ADDENDUM TO THE CONTRACT DOCUMENTS

ADDENDUM NO. 002
	Project: Solano Community College District Building 1600 Modernization Project Project Number: 25-009
	Date: July 12, 2024

1 1633 - CLASSROOM

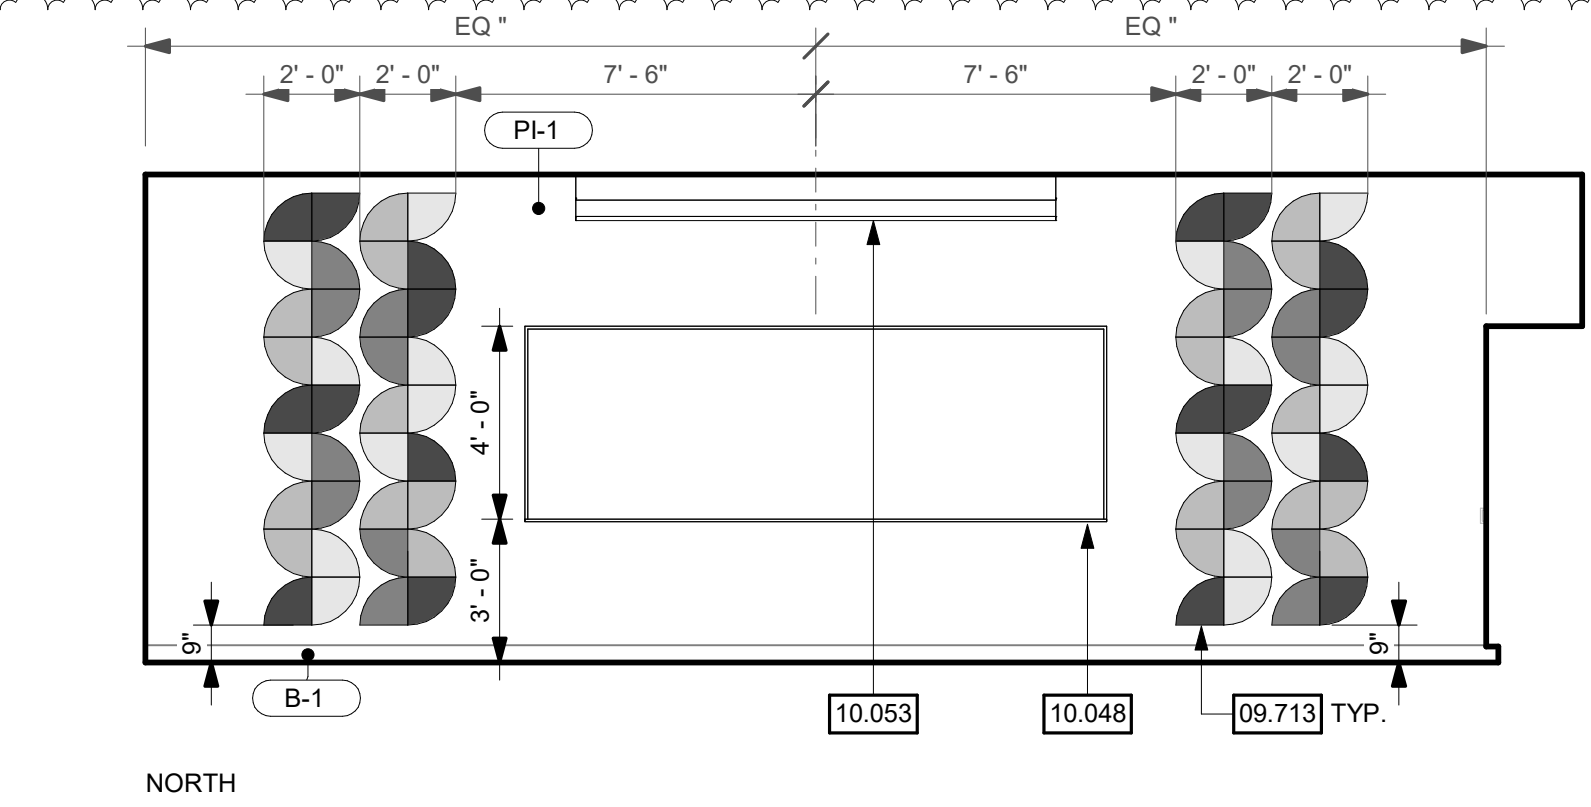
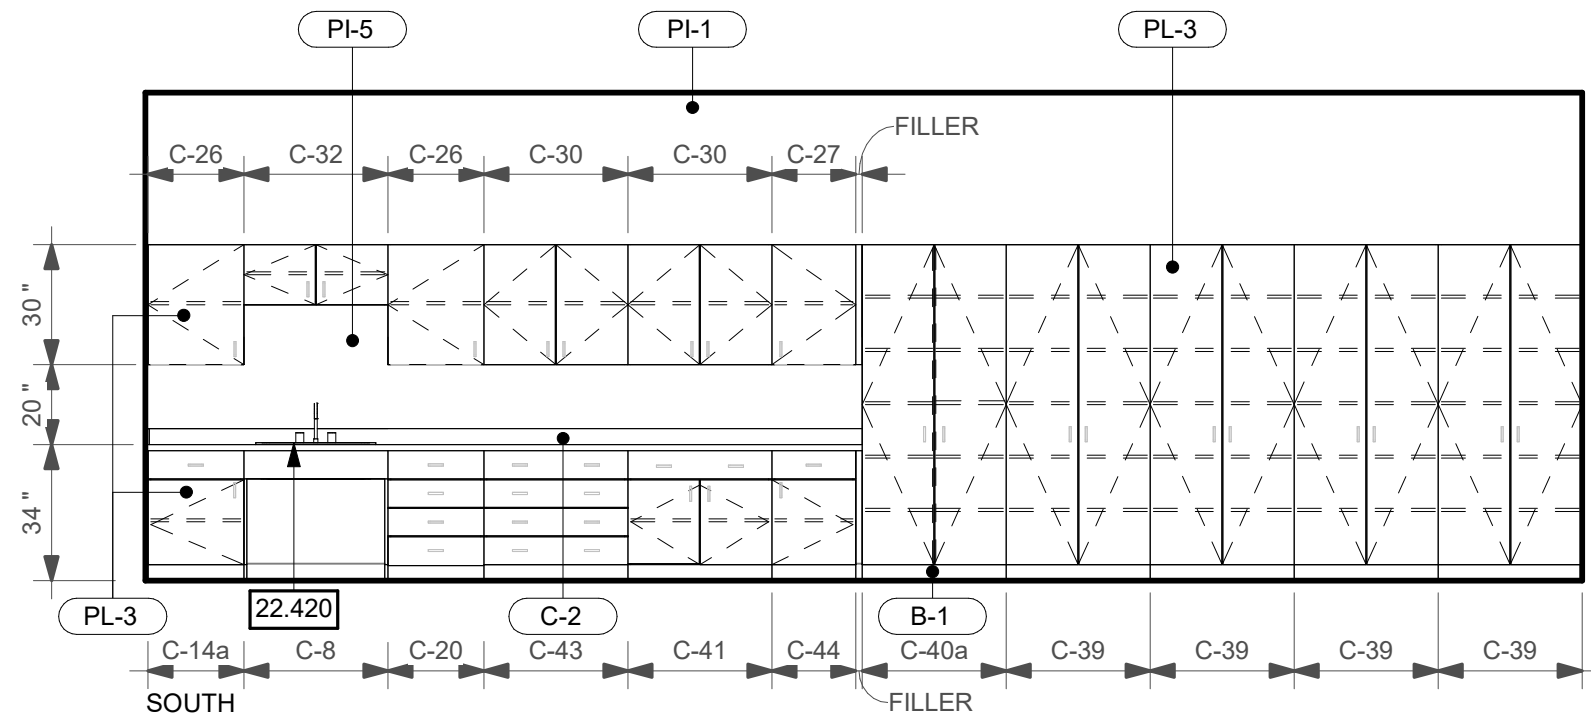
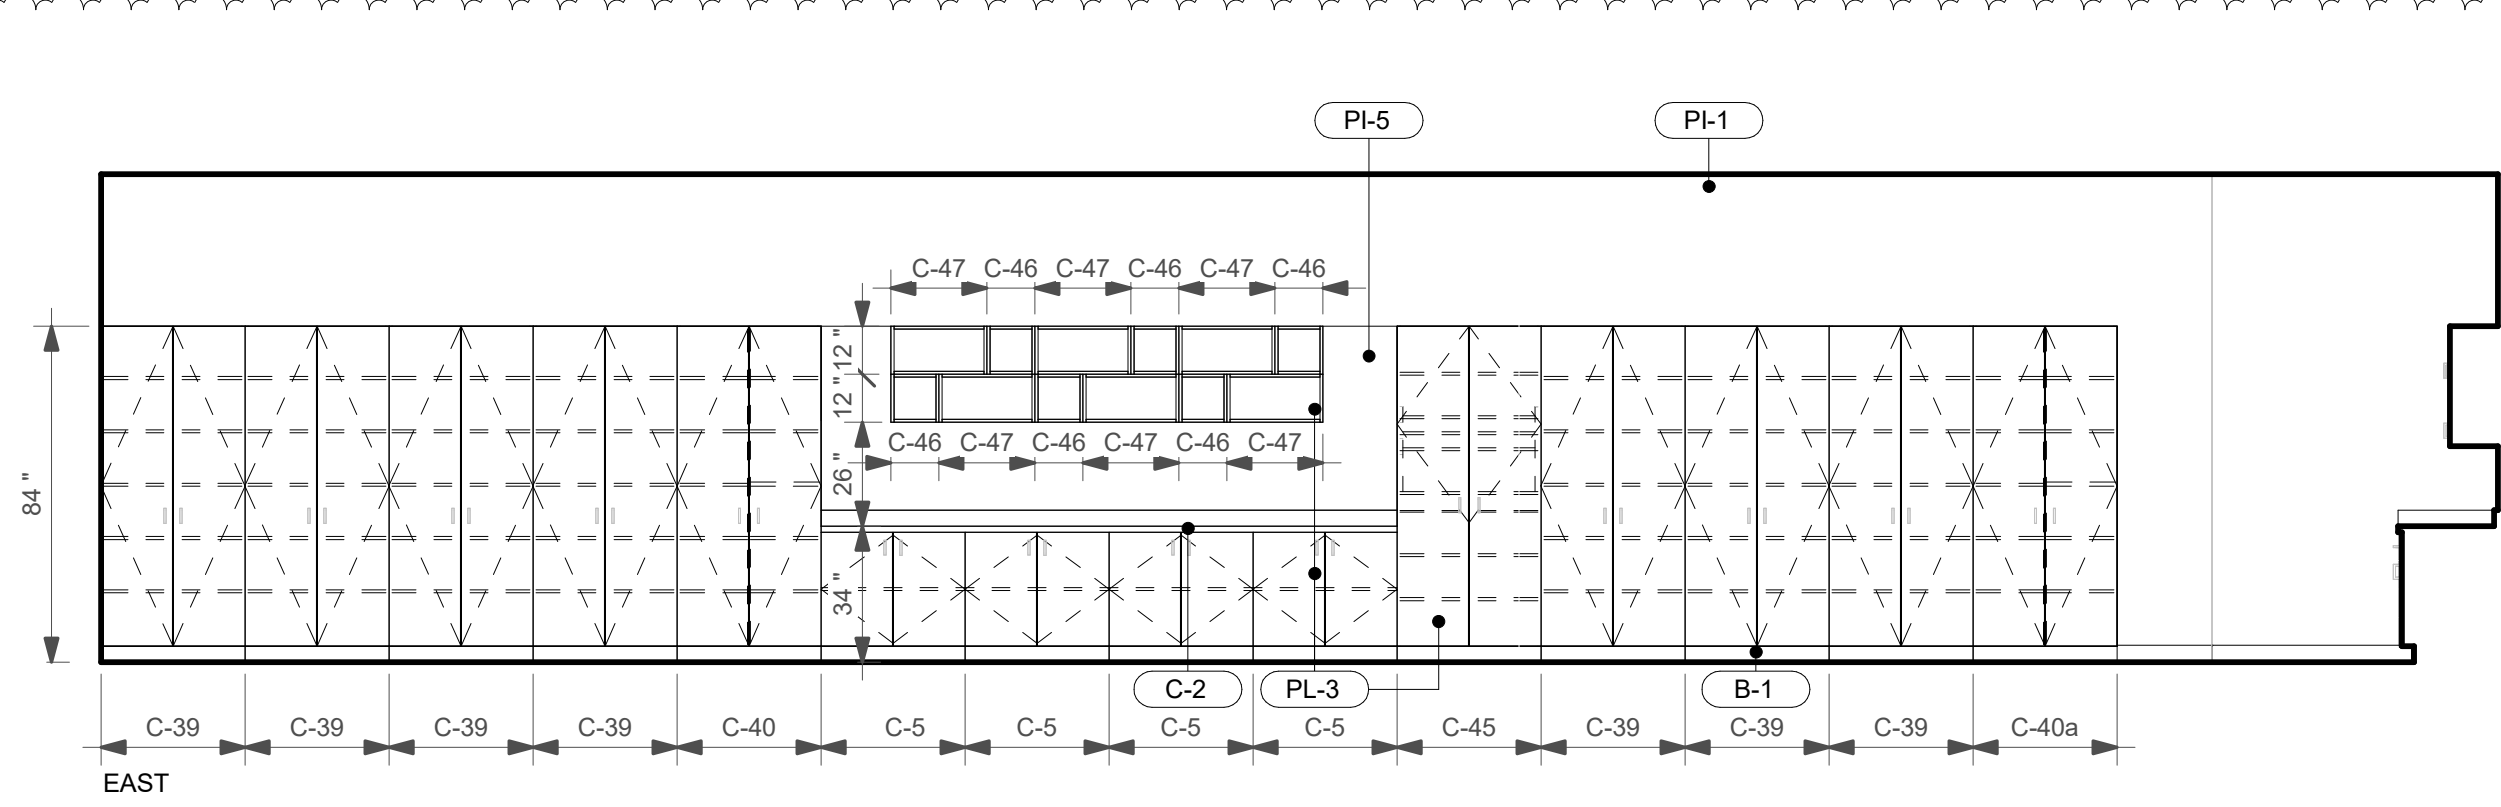
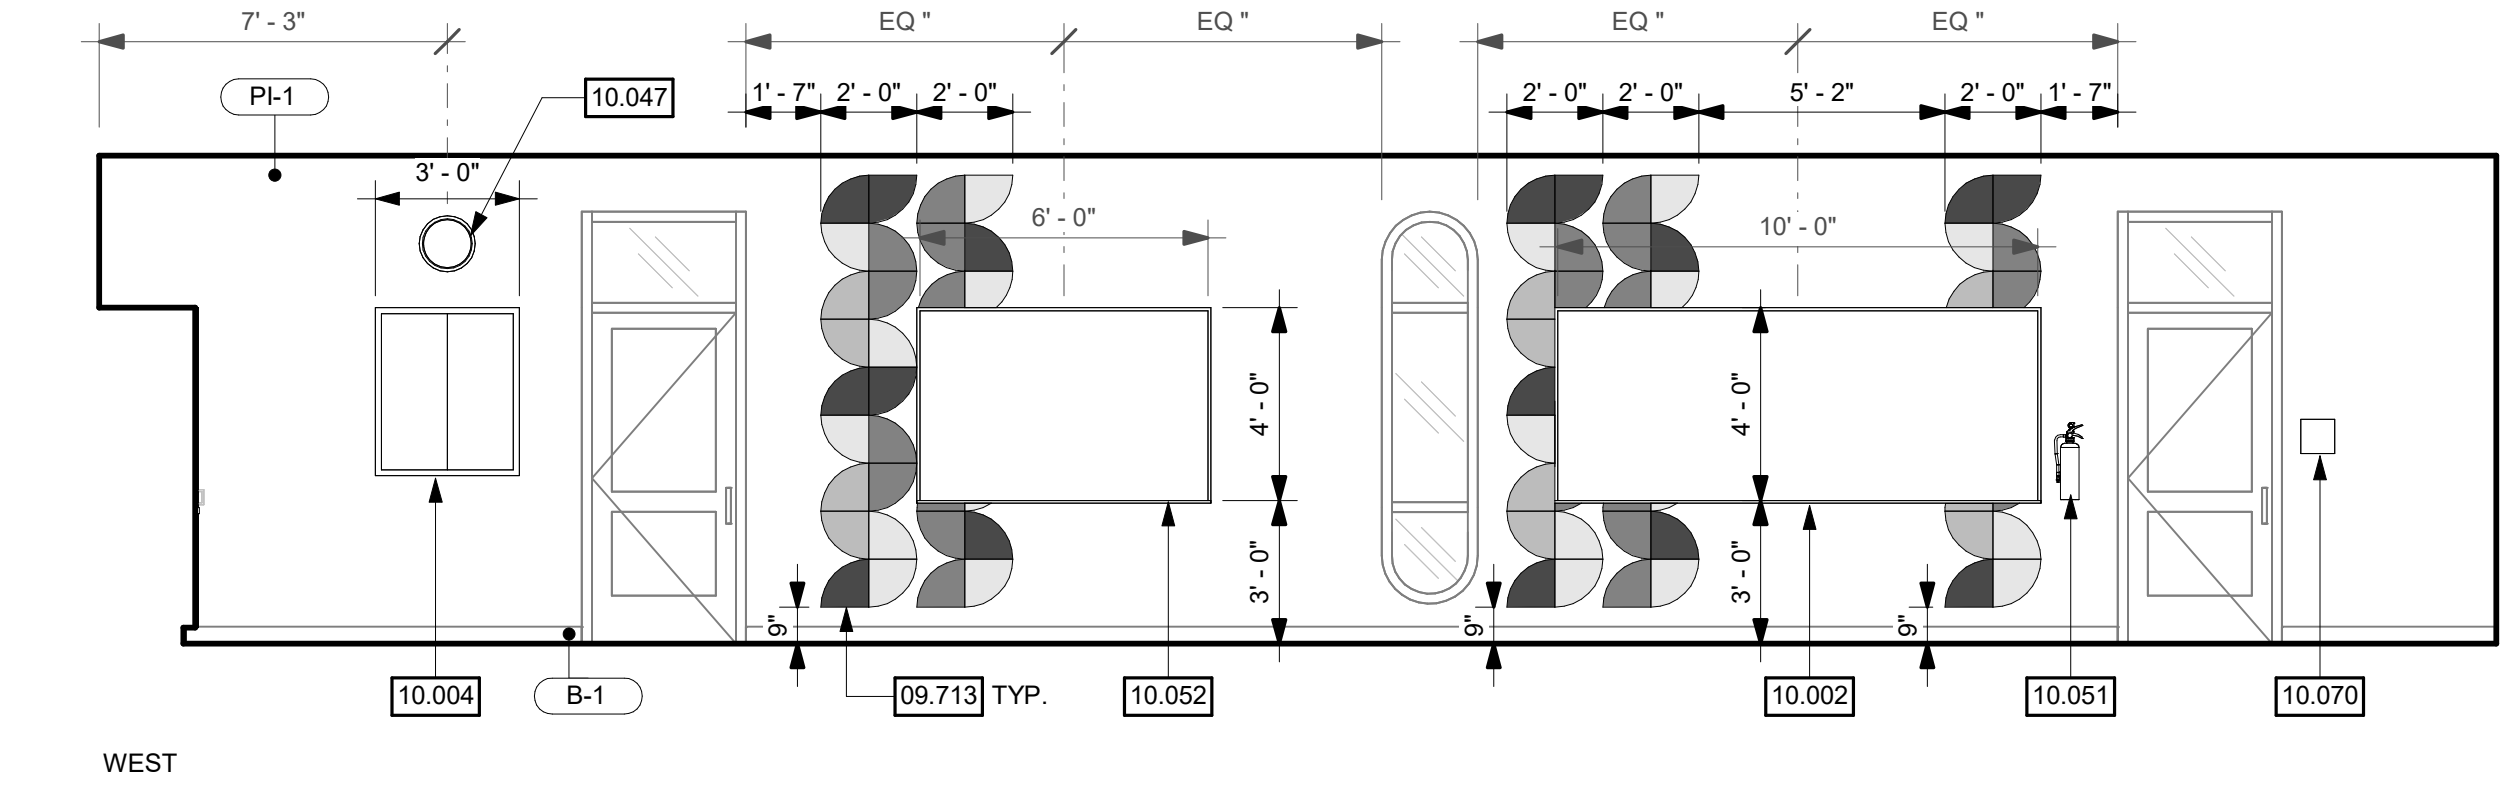
Remove: Elevations 2 – “1634 - Classroom” as shown on attached sheet AD2-A12.04
Revise: Elevations 1 – “1633 – Classroom” as shown on attached sheet AD2-A12.04
Revise: Elevations 3 – “1635 – Classroom – South” as shown on attached sheet AD2-A12.04
Revise: Finish legend PL-3 to read: “Plastic Laminate 3” as shown on attached sheet AD2-A12.04
Add: Finish legend PI-5 to read: “Interior paint accent 3” as shown on attached sheet AD2-A12.04

1 TECHNOLOGY SITE PLAN

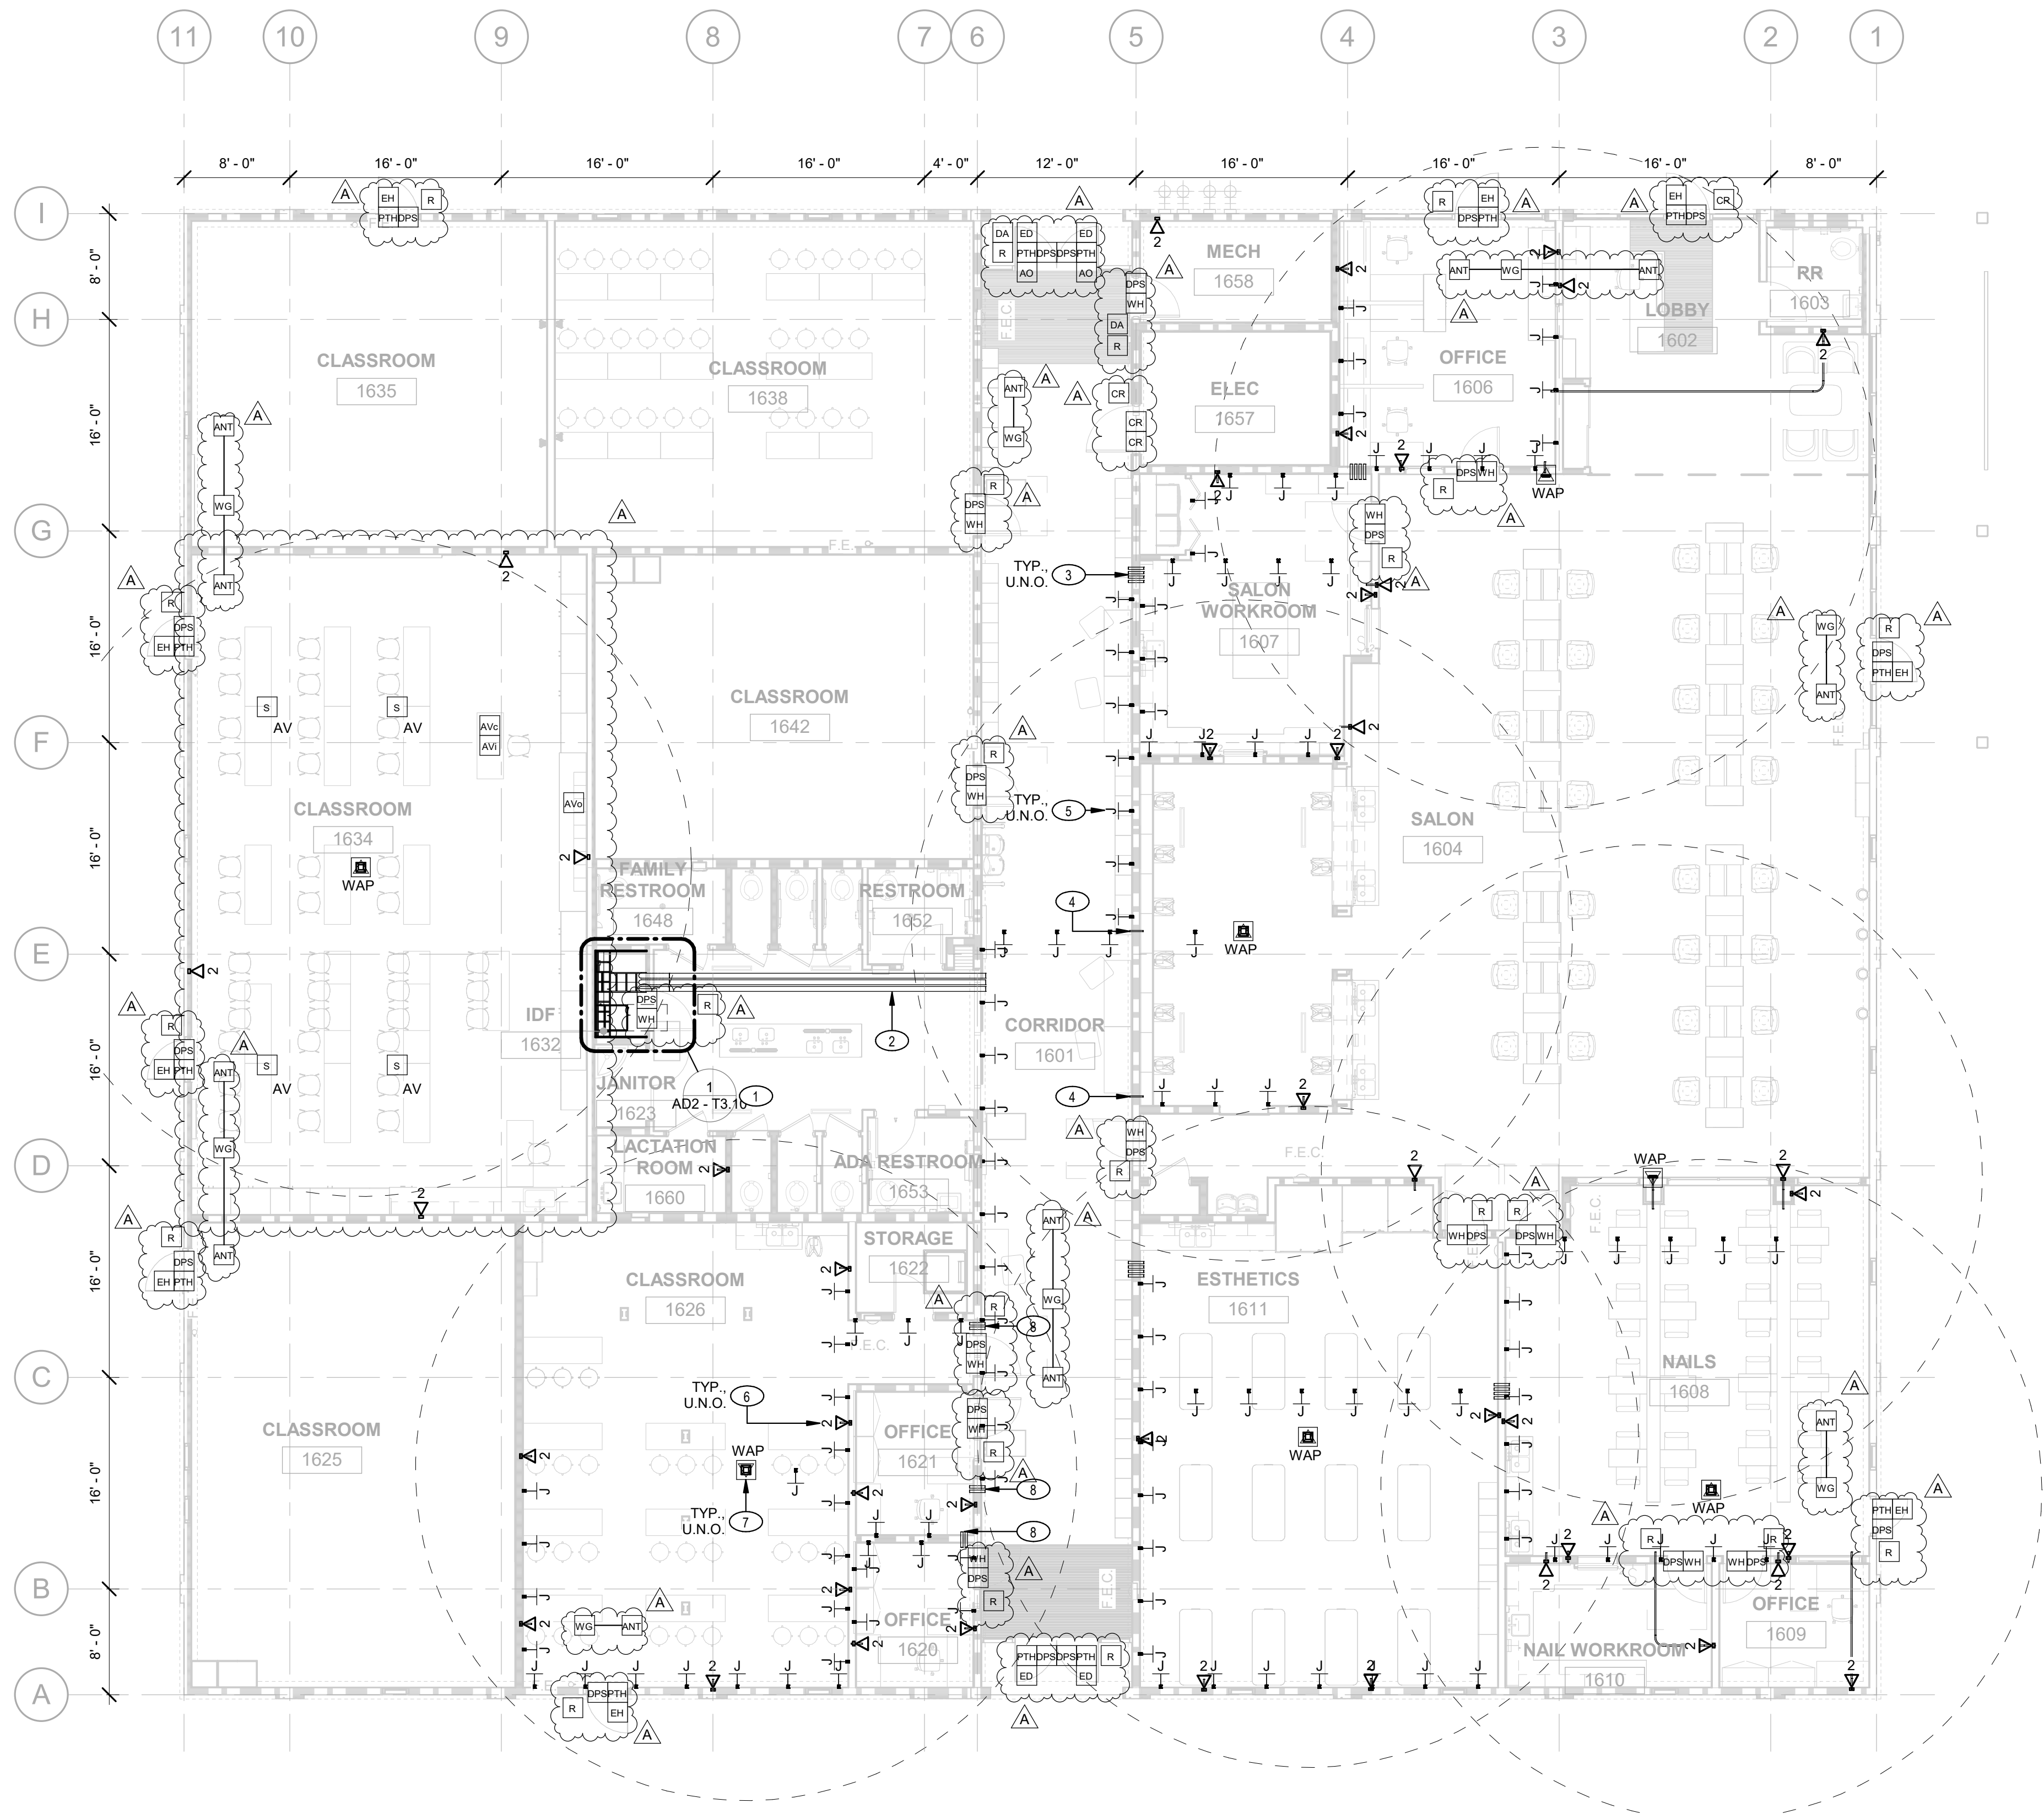
Existing 100-pair copper feed cable is to be demo'd and new 1 each 25-pair to be re-feed from the New IDF at Bldg 1600 to Existing IDF at Bldg 200. See attached sheet AD2 – T1.01 technology site plan
